FRDM-K64F Board Errata

1 Errata Title: I²C signals are swapped on I/O headers

Document Number: FRDMK64F_ERRATA

Figure 1. Swapped I²C signals Pin18 and on J2

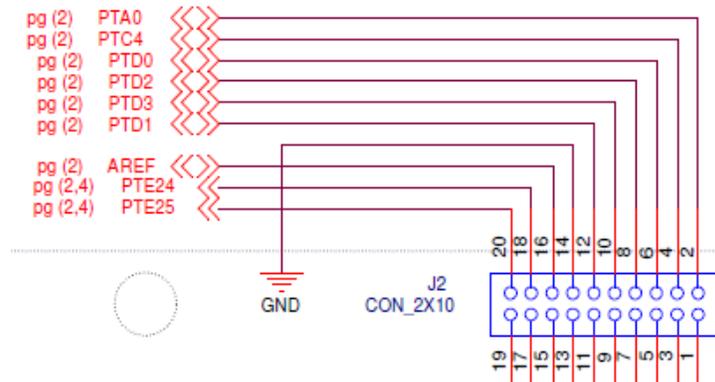
Description: Pin 18 (I2C0_SCL) and pin 20 (I2C0_SDA) of J2 I/O Header, and pin 10 (I2C_SCL) and pin 12 (I2C0_SDA) of J4 I/O Header are swapped. Figure 1 and Figure 2 show the incorrect signals.

1. Use jumper wires to connect between Arduino compatible shield signals to the FRDM board I/O header signals. Swap the jumper wires only on the I²C signals.
2. When pin 10 of J4 (PTC10) and pin 12 of J4 (PTC11) are not used on the shield, route pin 10 of J4 to pin 20 of J2 and pin 12 of J4 to pin 18 of J2. Configure PTE24 and PTE26 (pin 18 and pin 20 of J2) as GPIO, and use PTC10 and PTC11 (pin 10 and pin 12 of J4) as I²C signals.

Fix Plan: Fixed in FRDM-K64F board (700 Assembly Rev B, Schematic Rev D1).

Figure 3. Correct order of I²C signals on J2

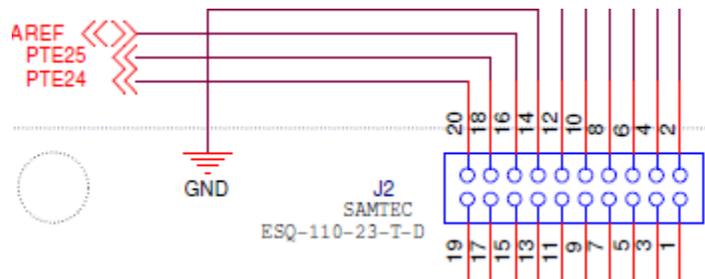
The correct position should be:
